SUNDRY NOTICES AND REPORTS ON WELLS

8. Well Name and No.
HARROUN TRUST 6 FED COM 1H

Mewbourne Oil Company has an approved APD for the above well. Mewbourne requests approval to make the following changes:

Mewbourne Oil Company, Pecos Valley 6/7 W2AH Fed Com #2H
Sec 6, T24S, R29E
SL: 10' FNL & 890' FEL
BHL: 2310' FNL & 330' FEL

WELL LOCATION AND ACREAGE DEDICATION PLAT

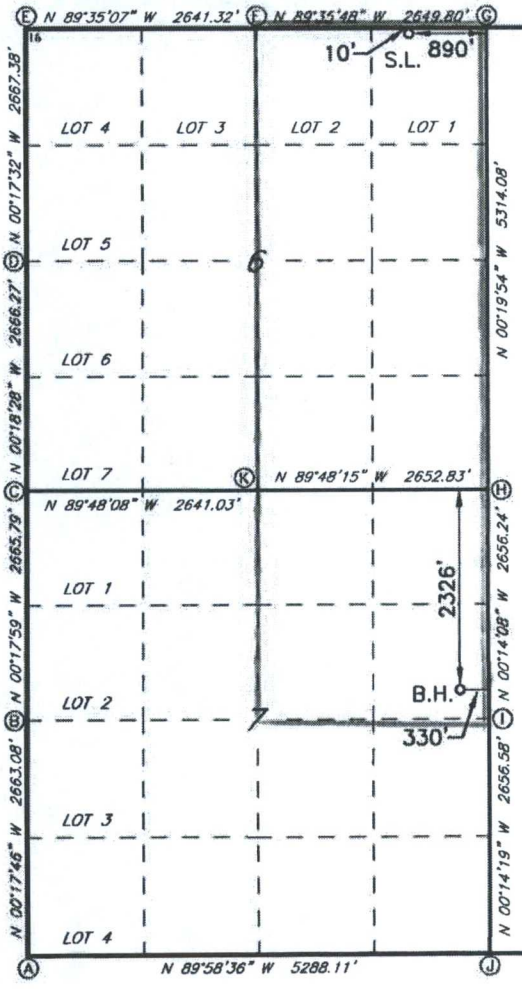
1) Change well name to Pecos Valley 6/7 W2AH Fed Com #2H. - 321207 - effective 4.1.2018
2) Change pool to 98220.
3) Change target zone to Wolfcamp & TVD to 10,927'. ✓
4) Change BHL to 2310' FNL & 330' FEL, Sec 7.
5) Change csg depth and cement to suit new plan.
6) Change wellhead to multi-bowl type wellhead.
7) Change well type to gas ✓
8) Change spacing to 480 acres. ✓
